New UN Regulation on Blind Spot Information Systems

Proposal for a new UN Regulation on uniform provisions concerning the approval of motor vehicles with regard to the Blind Spot Information System for the Detection of Bicycles

Submitted by the Informal Working Group on Awareness of Vulnerable Road Users proximity in low speed manoeuvres*

UN Regulation No. XXXECE/TRANS/WP.29/GRSG-2018-24e, amend to read:

Figure 1
Dynamic tests

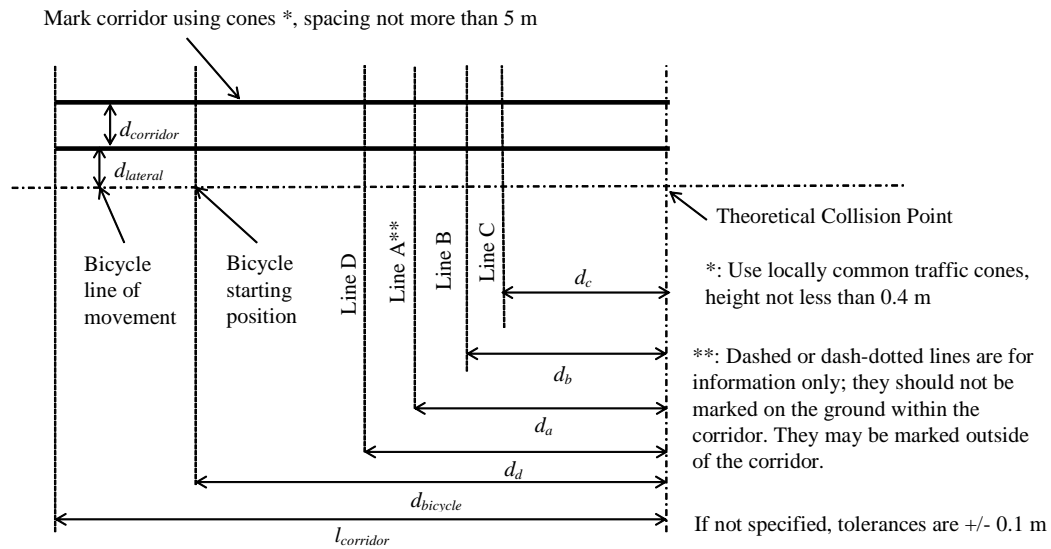
collision point as specified in Appendix 1, Figure 1. For vehicle speeds between 5 and 10 km/h, the value d_c shall be 5 m.

For vehicle speeds above 25 km/h, where the stopping distance is higher than 15 m, d_c as specified in Appendix 1, Figure 1 shall be as specified in Appendix 1, Table 2.

1. Small corrections made throughout the text for clarification in order to clarify things.
- ~~1-2.~~ Modification of value d_c to account for sensor range problems. A close analysis of the corresponding experimental data suggests that for tests performed outside of the test cases. Keeping value d_c at 15 m also for very low vehicle speeds leads to extraordinary high required sensor ranges that are not possible with today's technology.
- ~~2-3.~~ A separate annex 4 has been provided to give guidance when calculating the performance criteria for test configurations other than the tests specified in Table 1, Appendix 1.
